MANAGEMENT OF
ABANDONED
AGGREGATE
PROPERTIES Program

Addendum 1.1

Tender 24-04

This letter will serve as Addendum 1.1 for Contract 24-04

SITE PLAN : Existing

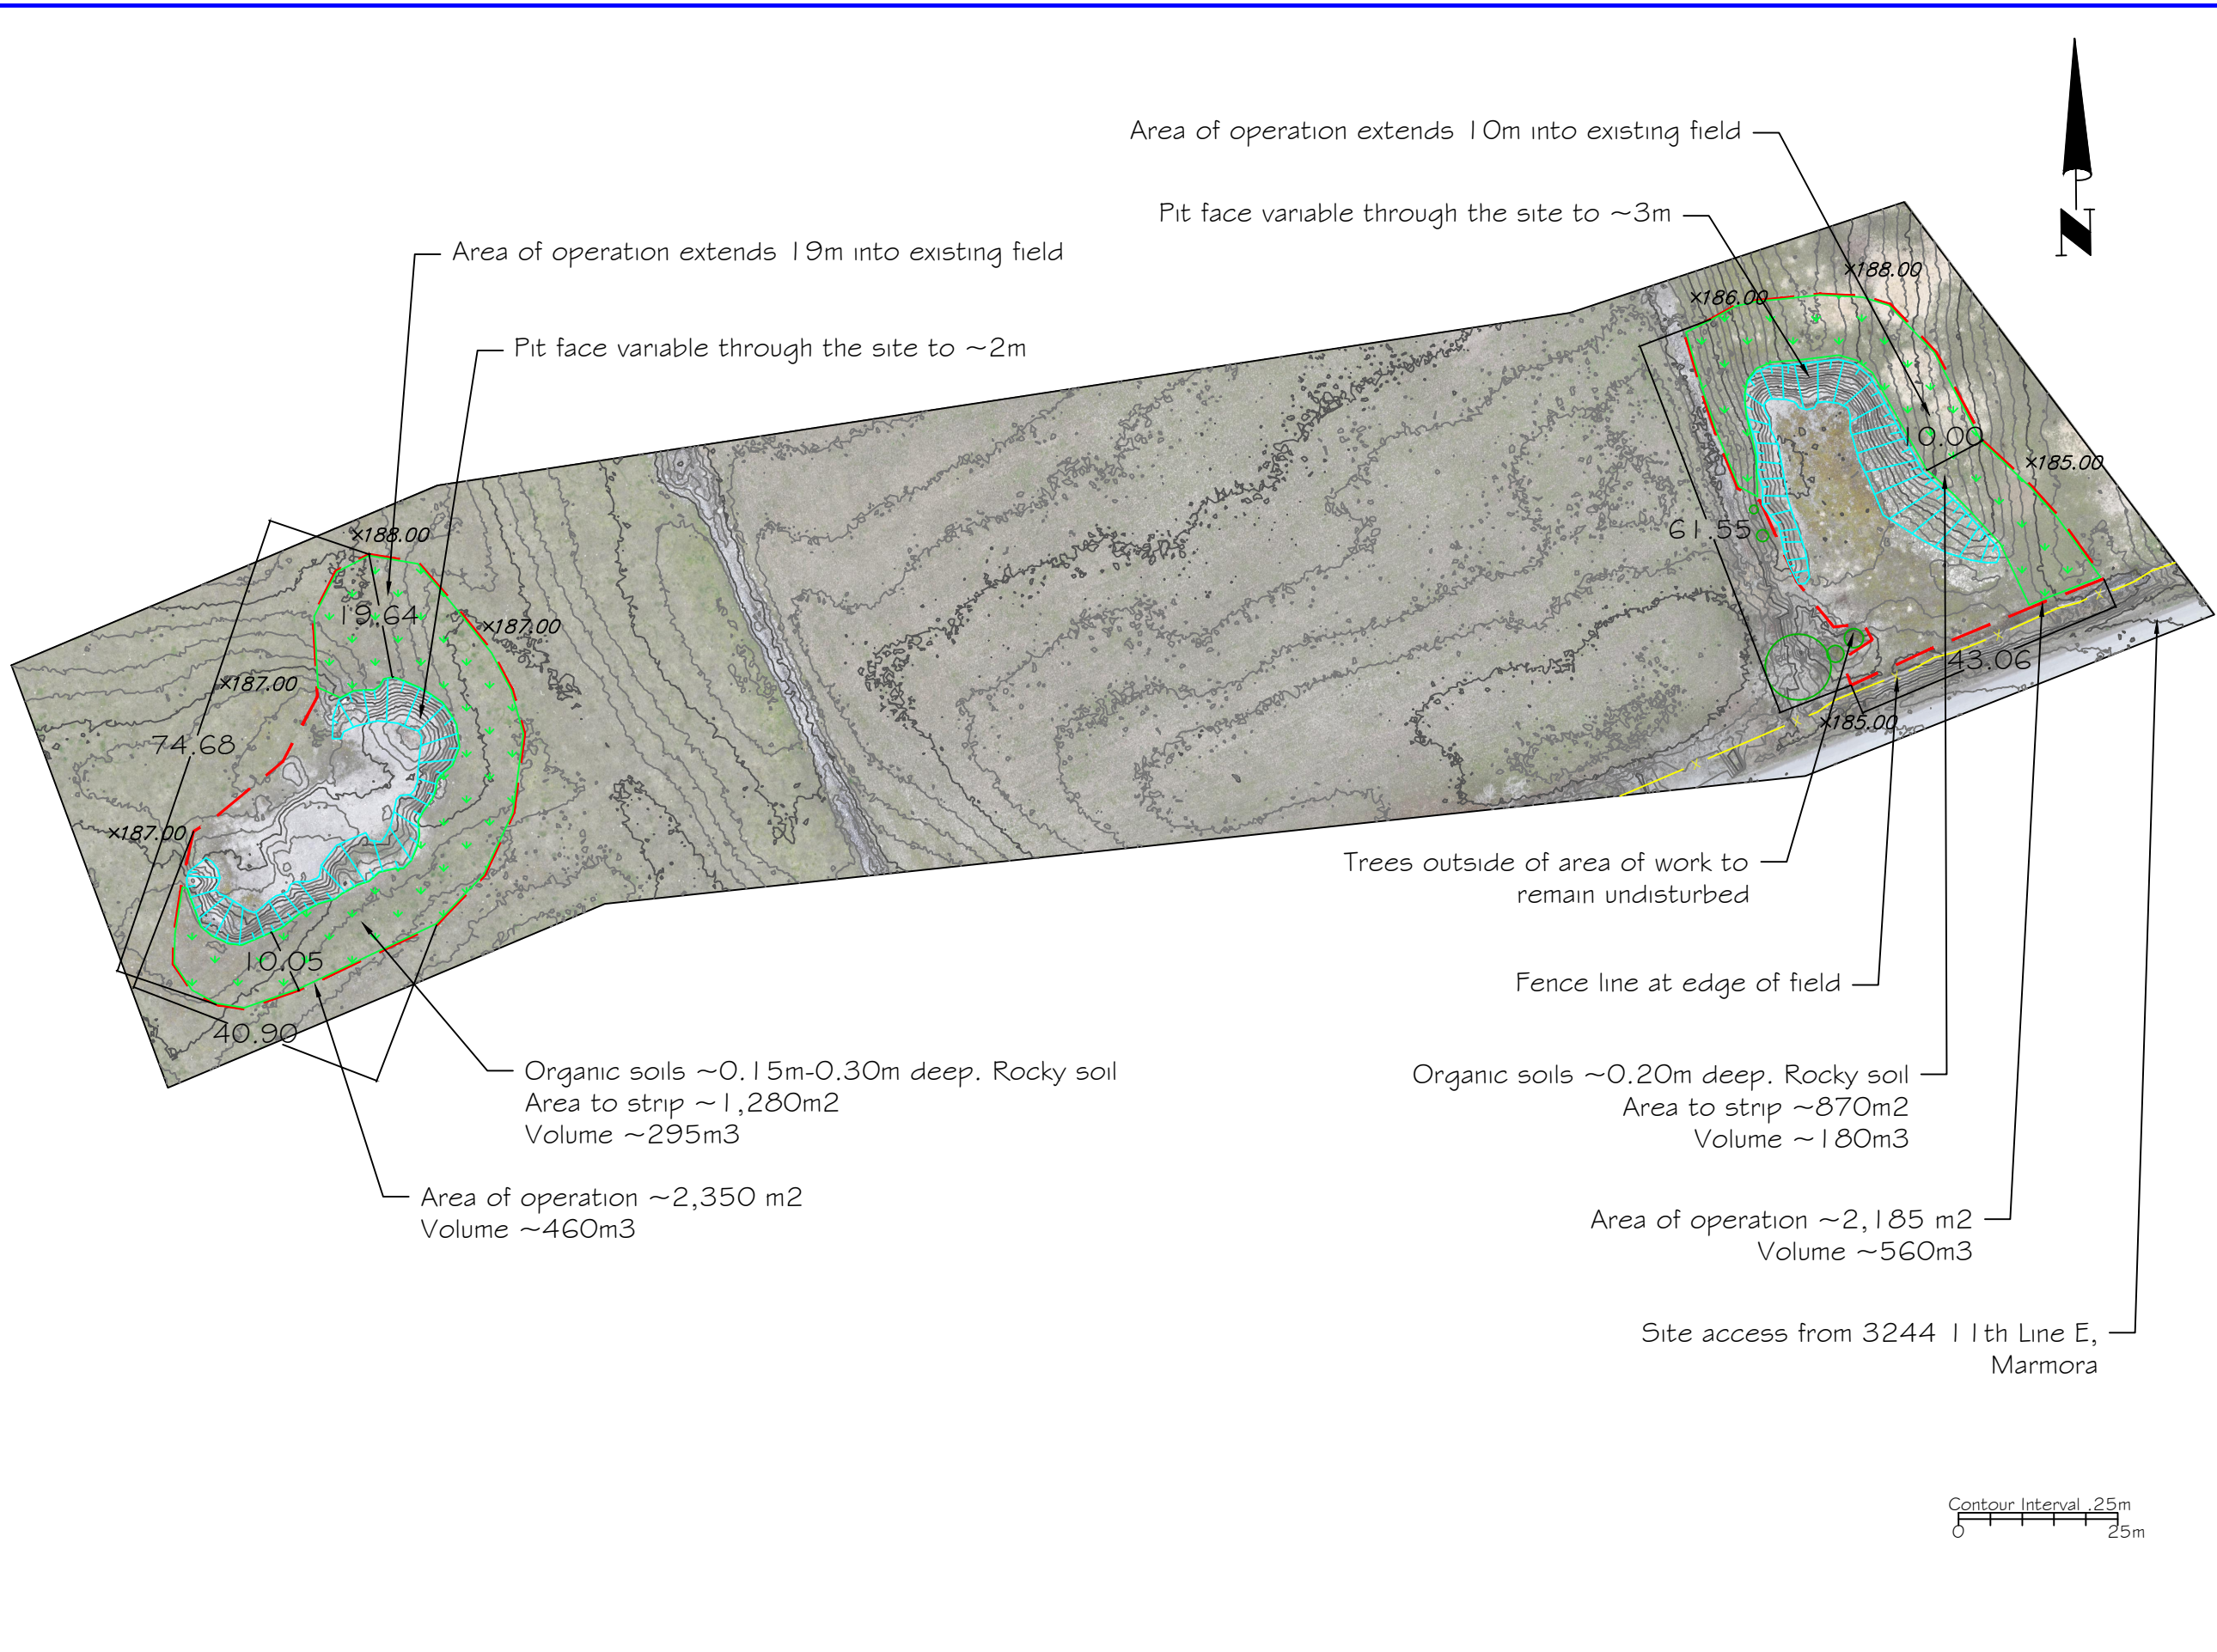
1. A correction has been made regarding the size of Site, 24-04e Muir, Lot 25, Concession 1, Township of Brighton, Northumberland County. **The working area of the site has changed from 0.050 ha to 0.44 ha.** Drawings have been updated to account for this change.
2. Site 24-04c Cripps 0.93 ha: Lot 15, Concession 2, Township of Percy, Northumberland County has added that a **single fence post be removed for construction and repaired upon completion**, to be included in PART A- Schedule of items and prices under *1.0 Site Preparation*.
3. Additional **soil condition notes** have been added to 24-0a and 24-04d.
